**Addendum No.2
To Plans, Contract Documents and Specifications
IFB 14-024/KJS, Electrical Vault Replacement**

JACK BROOKS REGIONAL AIRPORT
 JEFFERSON COUNTY, TX
 ELECTRICAL VAULT REPLACEMENT
 PACKAGE 1

Jack Brooks Regional Airport – Electrical Vault Replacement Pre-Bid Meeting

To: Potential Bidders
From: Thomas D Dodson, PE
RE: Jack Brooks Regional Airport – Electrical Vault Replacement Project
Bidder Questions
Date: July 10, 2014

SHEET NUMBER
A-102

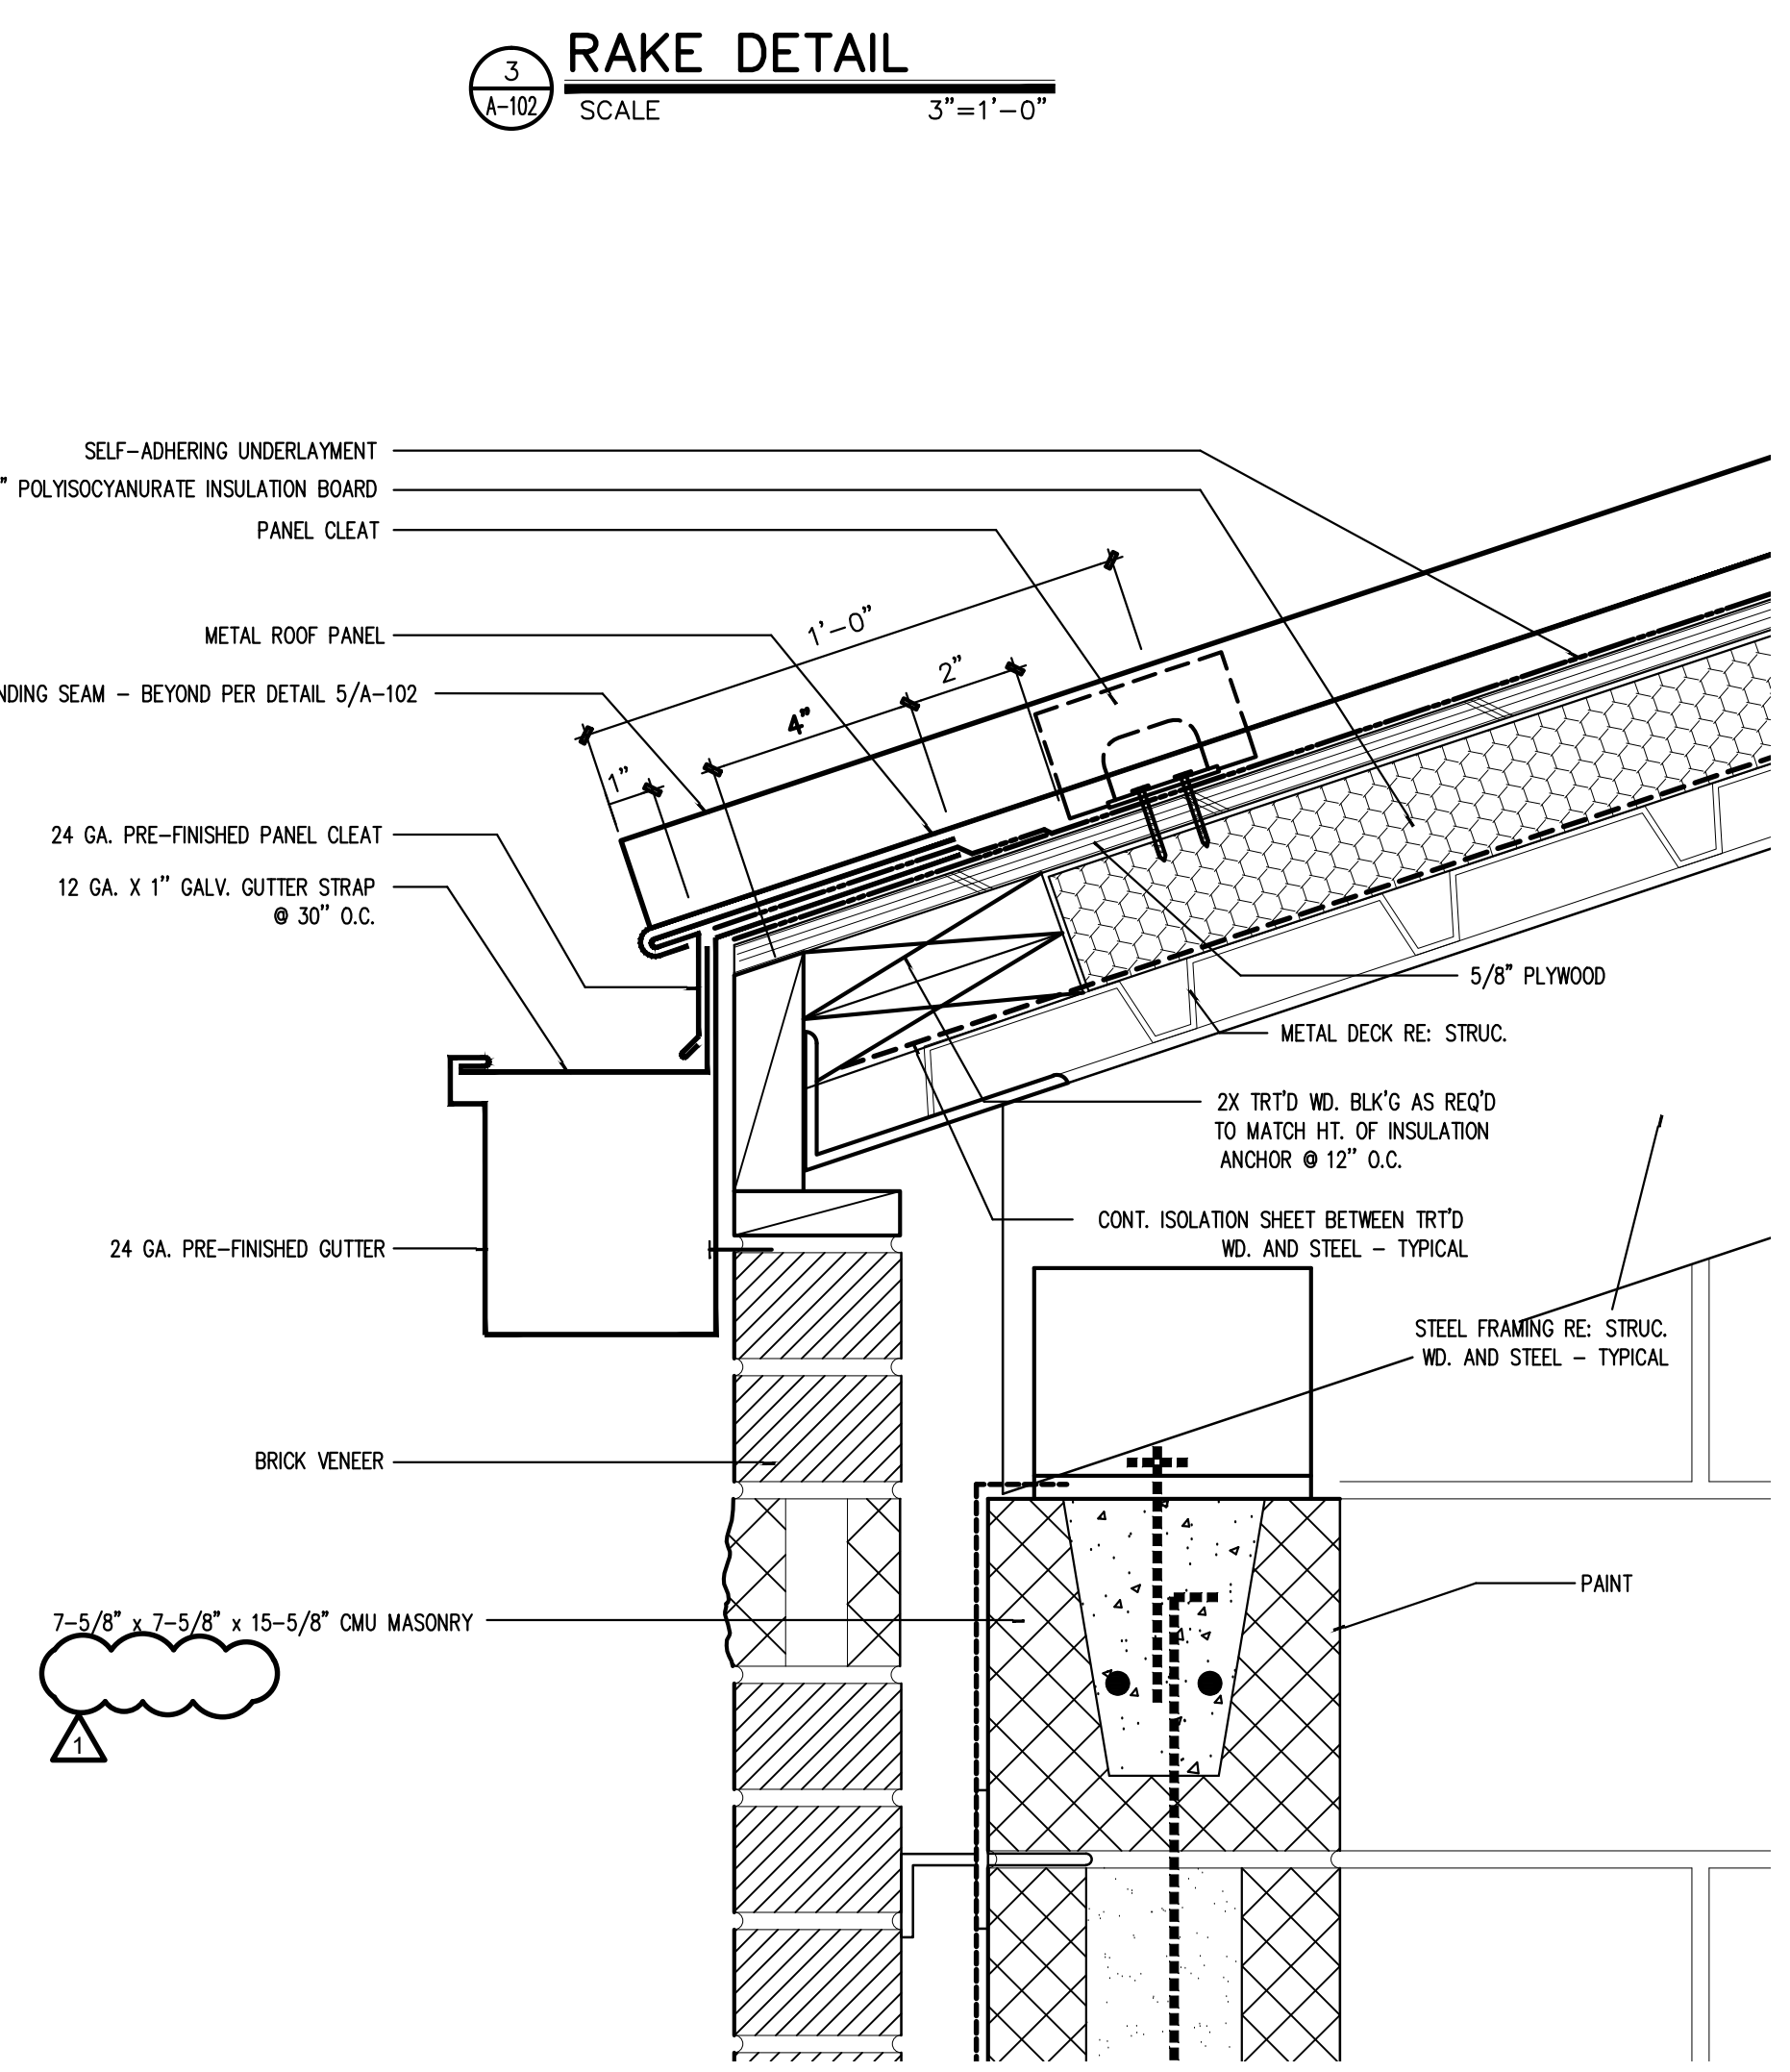
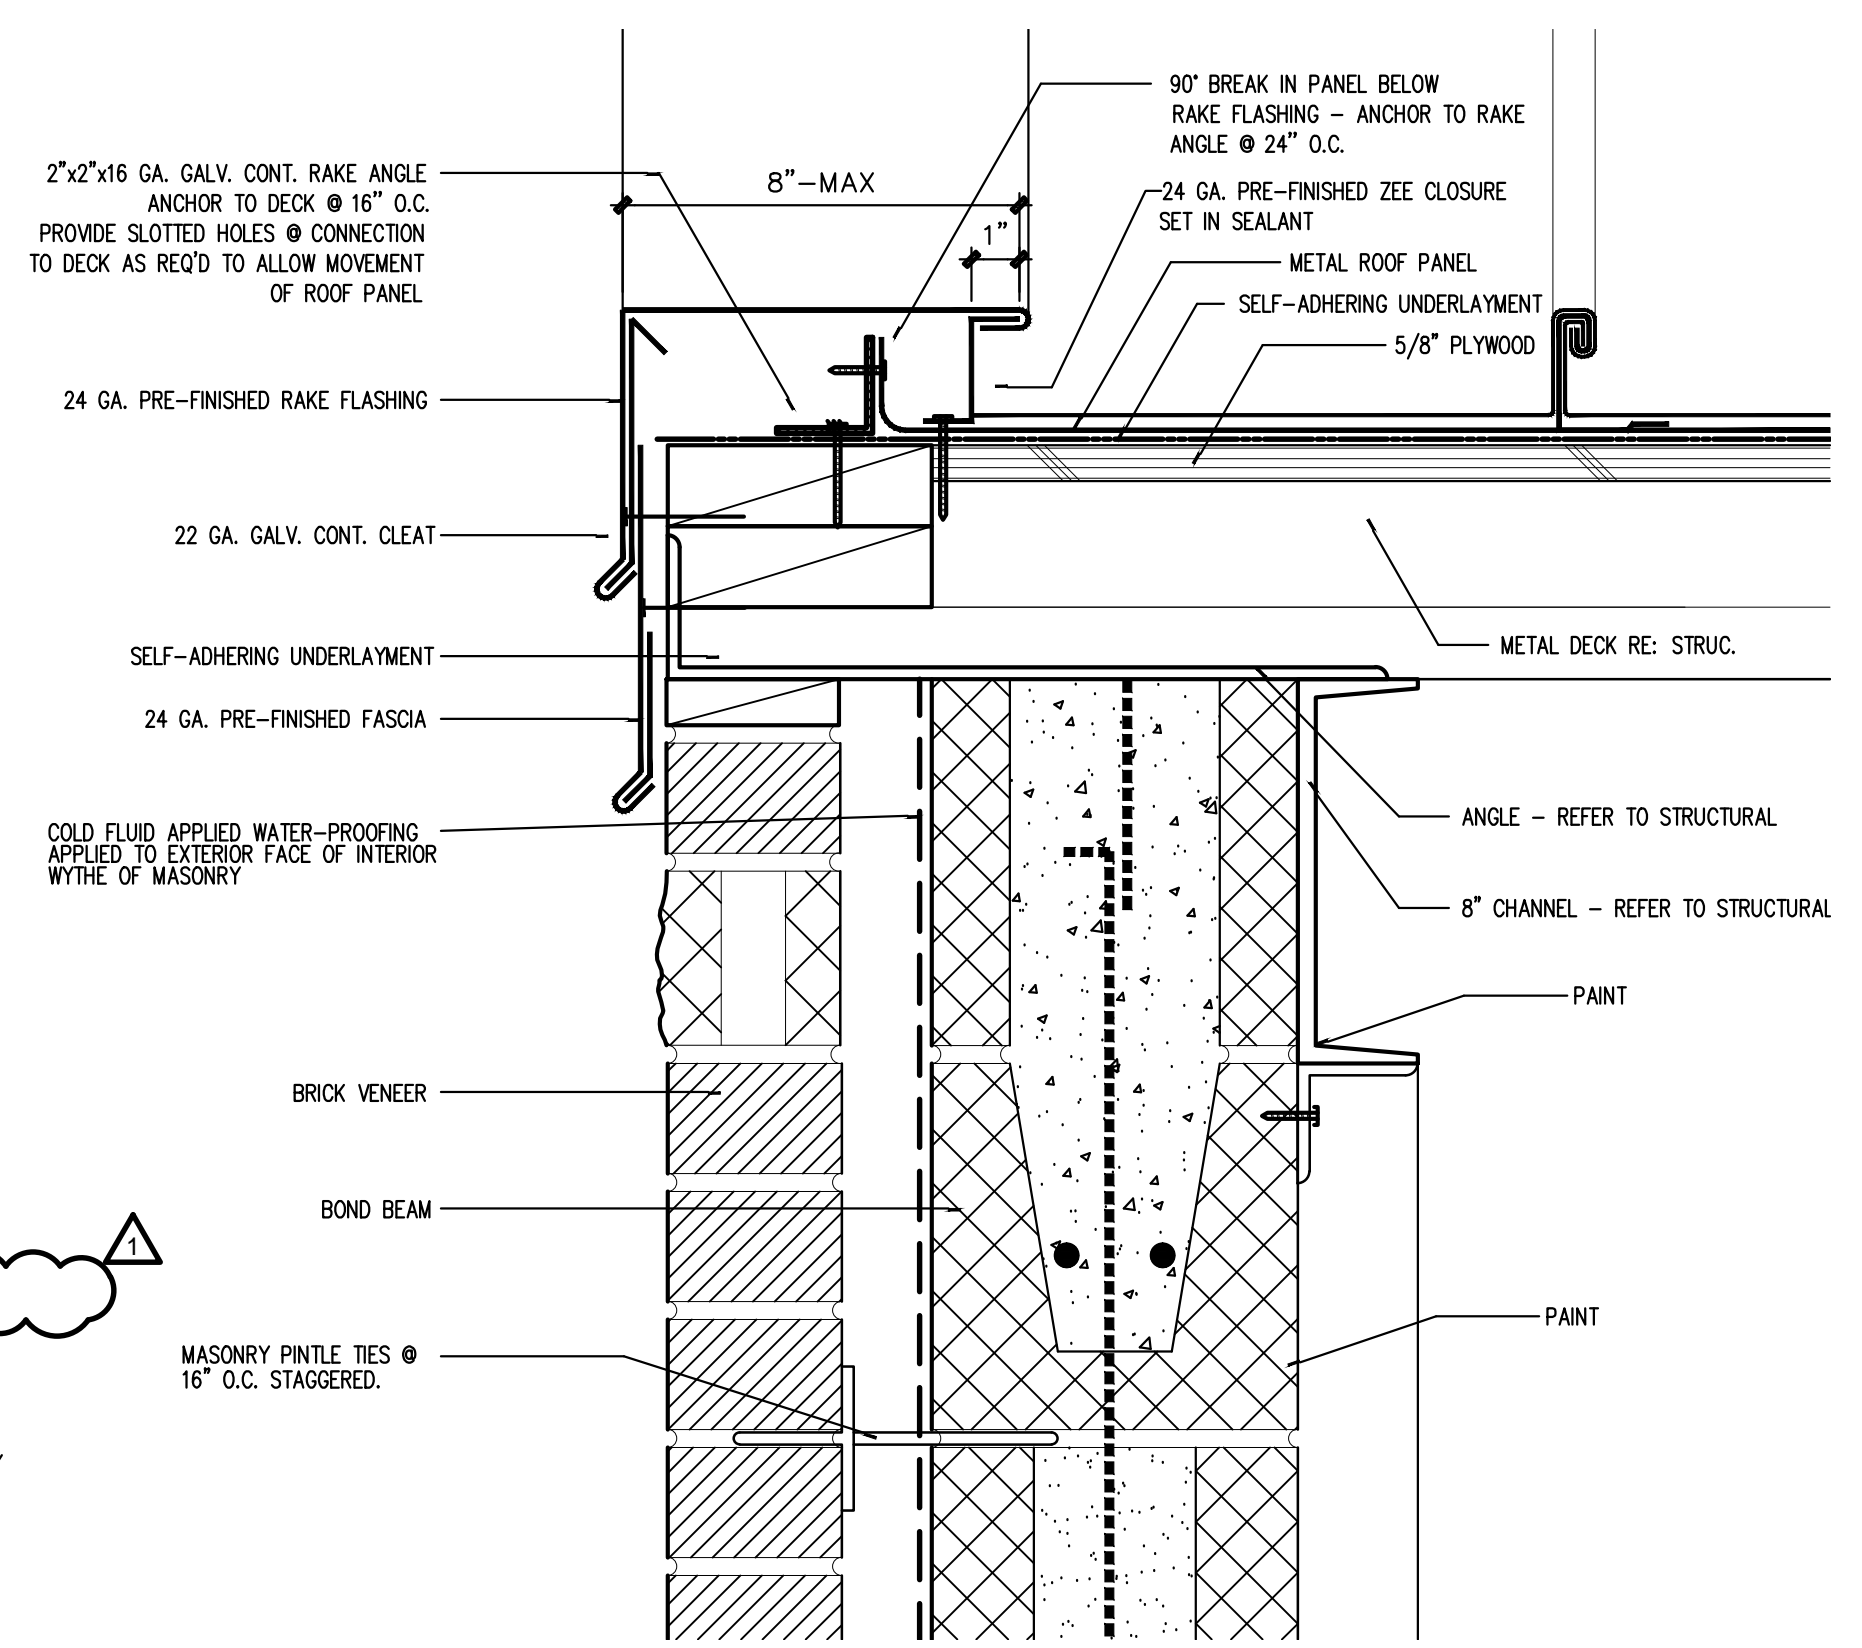
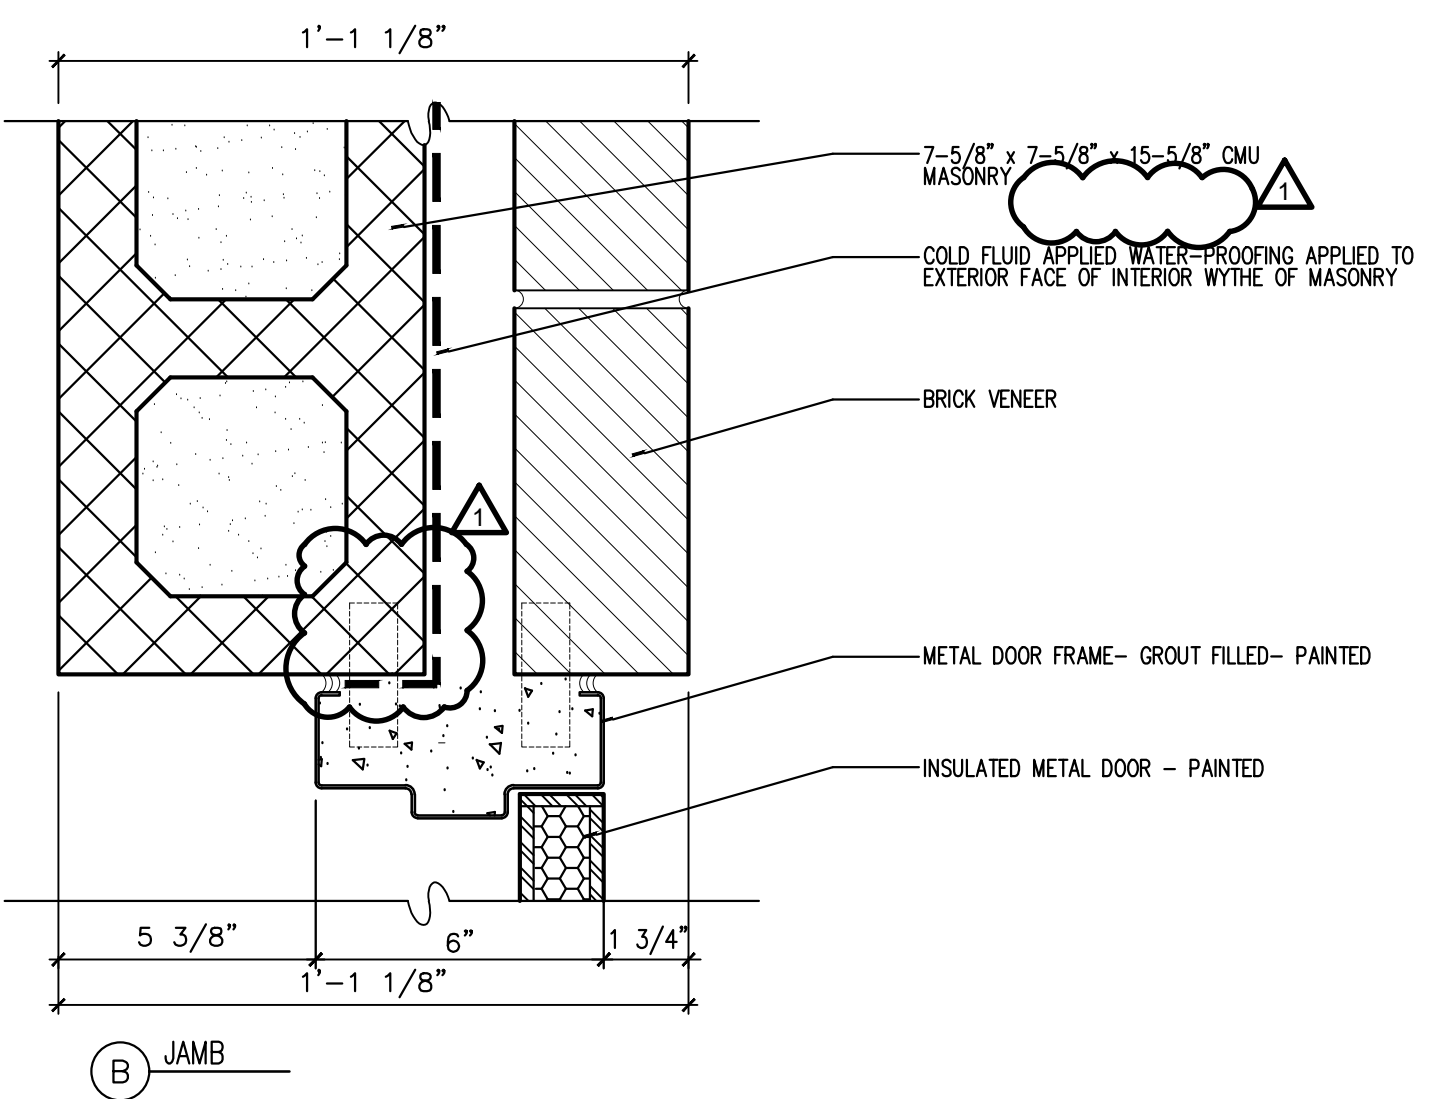
Question 5: In the building wall sections in the plans – what is the intent for fill in the CMU block?

Answer 5: On plan sheet A-101 Delete all references to perlite filled masonry. Load bearing CMU in this project shall be grout filled as directed on the structural drawings. See revised Sheet A-102 included in this addendum.
